TITLE: **7-Eleven Store #24347**

REQUEST: **Site Development Plan S-19-0007 Approval**
The Applicant is requesting Site Development Plan approval for the redevelopment of an existing 7-Eleven Convenience Store structure and site and the addition of fuel pumps.

STAFF REPORT

SITE DEVELOPMENT PLAN REVIEW COMMENTS:

SHEET TITLE:
FINAL LANDSCAPE PLAN
21 OF 29

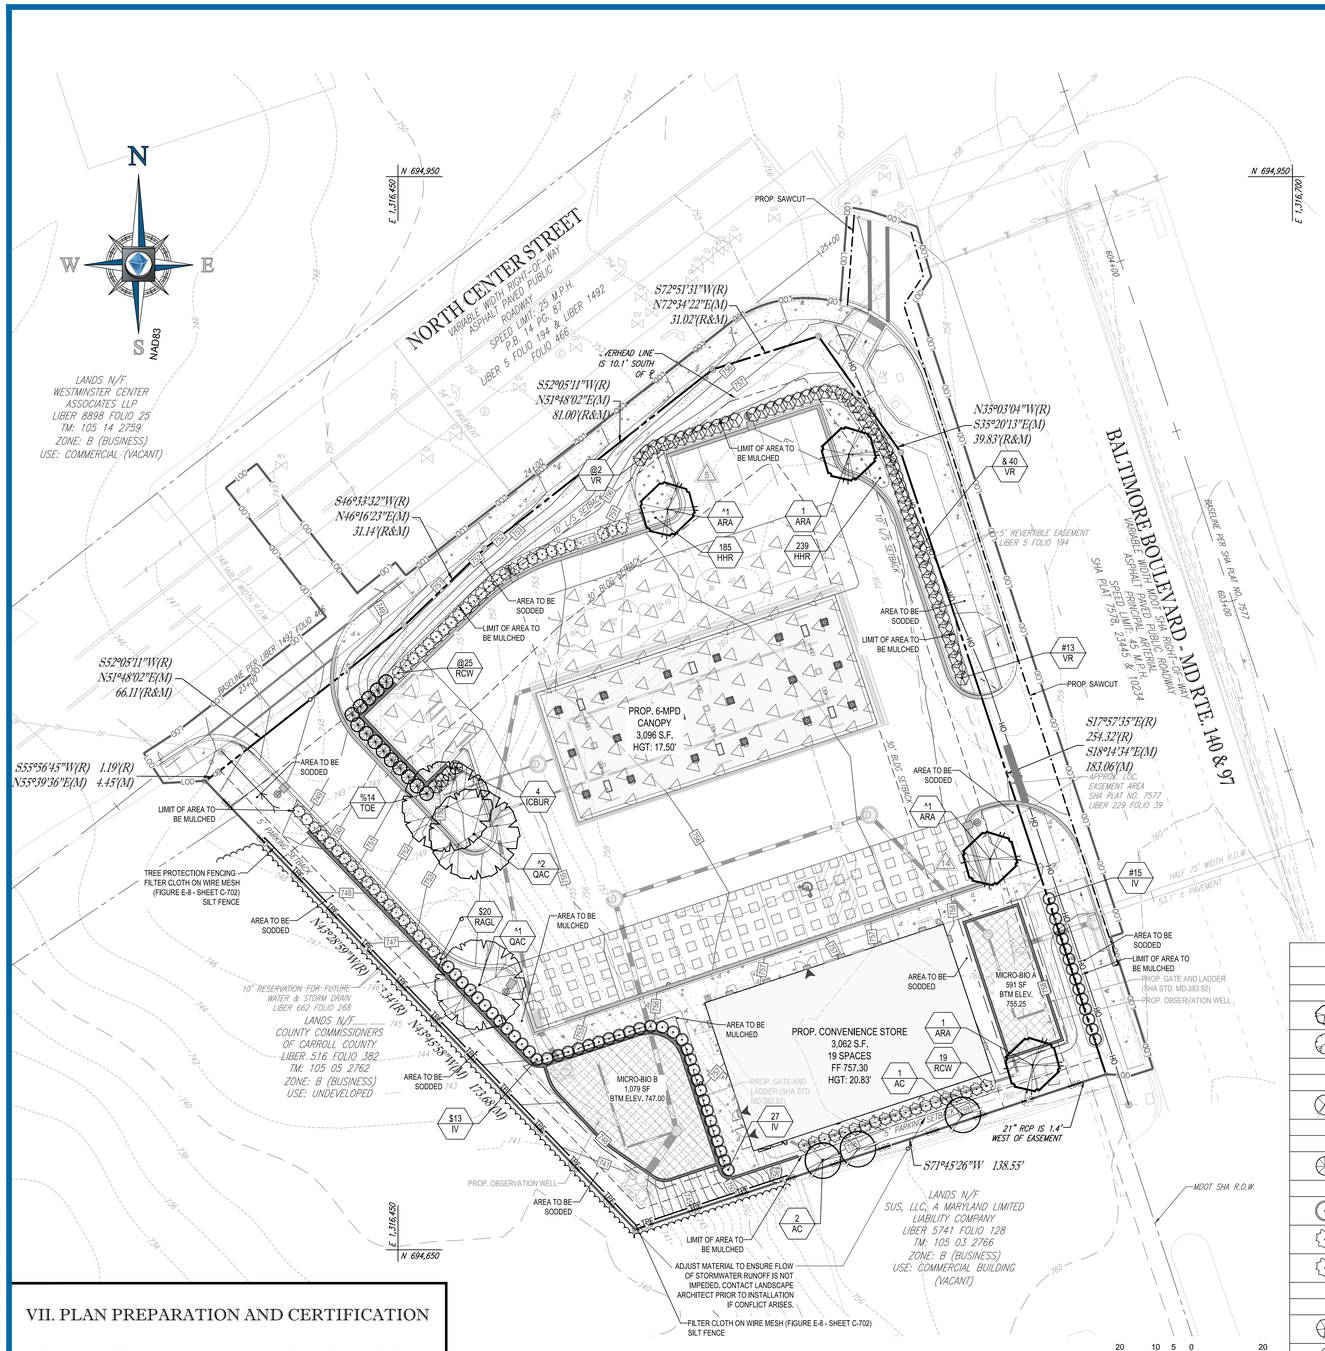
The first modification requested is to Landscape Standards and Criteria V.C.1.b. 7-Eleven is proposing a 6' wide landscaped planting area in lieu of the 10' wide landscaped planting area located between the abutting right of way of MD Route 140 and the proposed gasoline canopy. 7-Eleven is not proposing a reduction in the required number of planting units within the proposed 6' wide planting area. The Applicant's justification for this modification is because 7-Eleven has been a fixture at the corner of N. Center Street and Baltimore Boulevard for many years. The proposed site development plan will continue to provide a presence for many more years. This lot is unique in a few ways. It is small in size when compared to modern convenience store locations. There is also an extreme topographical change of approximately 13' in elevation from the existing entrance on N. Center Street to the entrance on Baltimore Boulevard. This change in elevation created a need for a driveway ramp which consumed additional property. The proposed entrance configuration will create a safer traffic pattern by closing one of the two entrances onto Baltimore Boulevard and realigning the approach onto N. Center Street. The Director of Community Planning & Development is amendable to the requested modification conditioned upon additional planting along Baltimore Boulevard and the western property line to screen the proposed adjacent SWM facilities.

The second modification requested is to Landscape Standards and Criteria Section V.C.1.d which requires landscaped islands to include a major deciduous tree. However, Landscape Standards and Criteria Section V.D.2 states "*trees may not be planted within an area which would adversely affect streetlights or underground utilities. No major deciduous trees or coniferous trees may be planted under overhead power lines or within 15 feet horizontally of overhead lines. If this condition conflicts with other requirements the Director will consider and rule on alternatives which best meet the intent of the manual*." The Applicant's justification for this modification is that existing overhead power lines run parallel to both N. Center Street and Baltimore Boulevard right of way lines. Due to the location of the overhead power lines, one landscape island at the northeast corner of the Property cannot meet the major deciduous tree requirement of Section V.C.1.d. 7-Eleven is proposing an Armstrong upright maple. With a mature width of only 15' (7.5' from center), this tree will not interfere with the overhead wires causing maintenance issues and will interfere less than a typical shade tree planted at the permitted 15' distance permitted within

the manual. The mature height will still be up to 40' which will provide cool shade for the pavement surface. The Director of Community Planning & Development is amendable to the requested modification.

Pursuant to Zoning Ordinance Section 164-131.1., Compliance with Landscape Manual, CP&D staff has reviewed S-19-0007 for compliance with the Landscape Manual, as well as, the above referenced modification requests and other applicable Zoning Ordinance landscaping regulations. With the exception of the two modification requests and some minor revisions needed to the landscape plan, S-19-0007 meets all other landscaping requirements of the Zoning Ordinance.

3. Obtain all required approvals for the two requested modifications to the Landscape Manual as outlined in the June 11, 2020 Planning and Zoning Commission Site Development Plan S-19-0007 Staff Report.

DF PYLON SIGNS

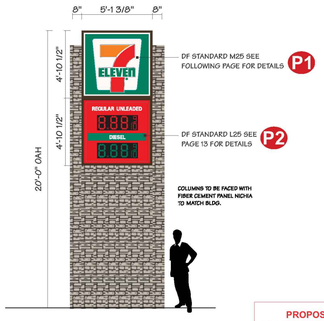
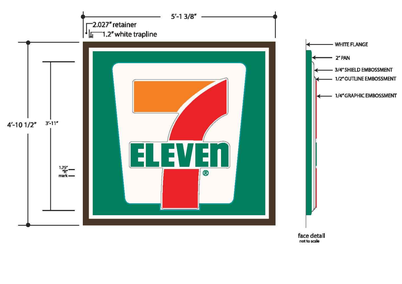
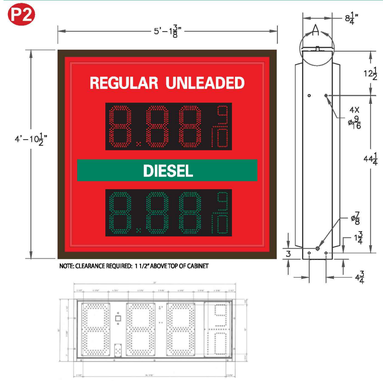
Staff has not had enough time to analyze the signage that is proposed with this plan. Staff recommends that any approval of this site plan should not include approval of the signage with the exception of the proposed 20 feet brick style monument free standing. If necessary, any other signage requiring Commission approval would be brought back to the Commission for action.

As stated above, the Applicant has proposed a 20 feet brick monument style sign which is inconsistent with the preferences and expectation of the DDP. The Applicant has submitted a modification request to the DDP to allow for the proposed 20 feet brick monument style sign. The sign structure material is compatible with and of similar design as the architecture of the 7-Elevan building. However, the height of the monument sign, particularly the monument base height of the sign, is inconsistent with the preferences and expectation of the DDP and does not create attractive signage along a principal thoroughfare of Baltimore Boulevard. Furthermore, a lower profile monument style sign would decrease signage along Baltimore Boulevard from becoming an eyesore or a driver distraction. Staff does not support the requested modification and has recommended that the Applicant reduce the height of the sign to 12.5 feet making the sign consistent with the preferences and expectation of the DDP and eligible to be processed administratively and not requiring Commission approval or a modification to the DDP.
